> Re: NRG Energy, Inc. Responses to Connecticut Siting Council Interrogatories; Docket No. 907

### CONNECTICUT SITING COUNCIL'S INTERROGATORIES TO MONTVILLE POWER LLC

Montville Power LLC August 27, 2009

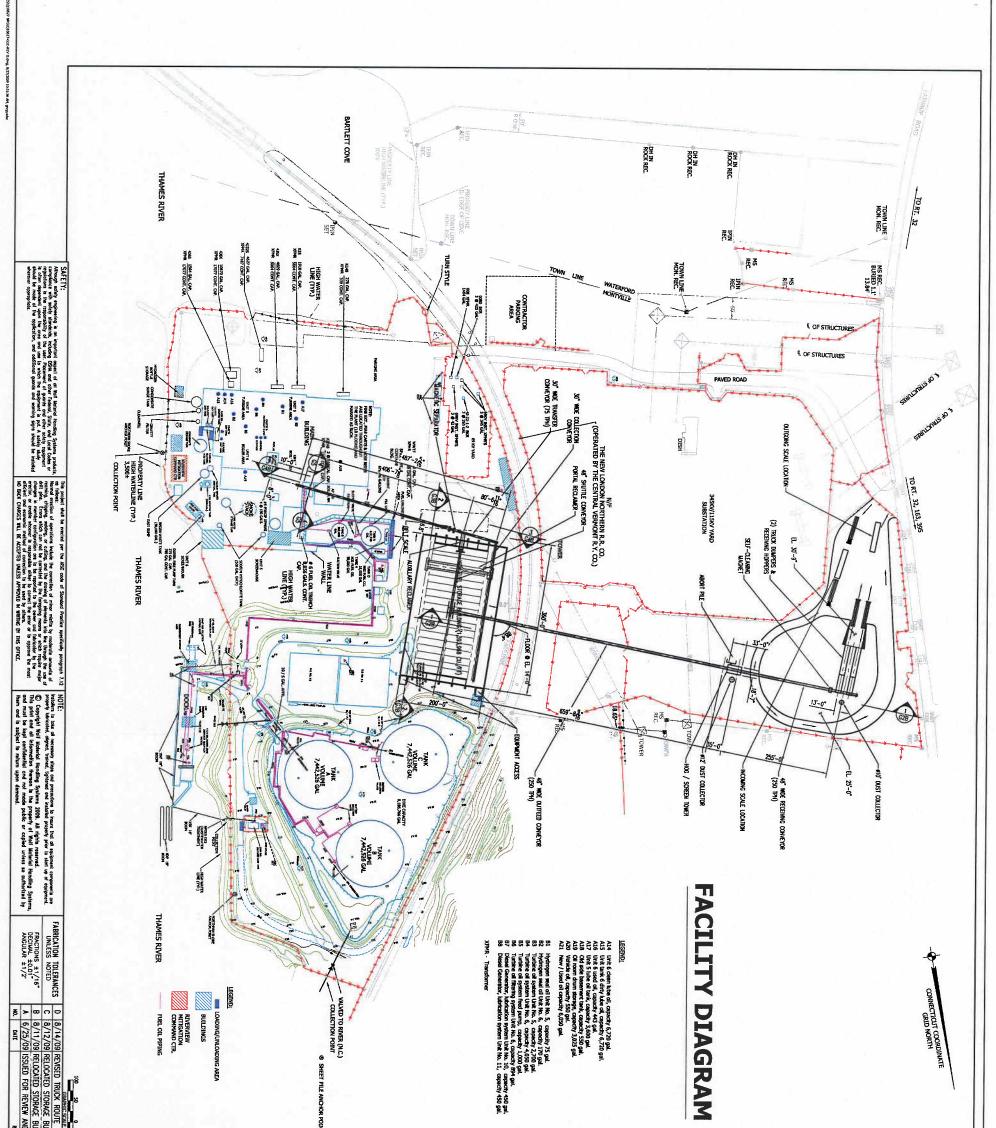
- 3. Provide a legible color copy of the diagram behind Tab B. Please depict NRG's property boundary and limits of vegetative clearing on the diagram.
- **<u>RESPONSE</u>**: NRG does not have a color copy of the diagram included in the petition as Attachment 8. An updated color drawing of the layout for the receiving yard is attached as Attachment CSC-3.
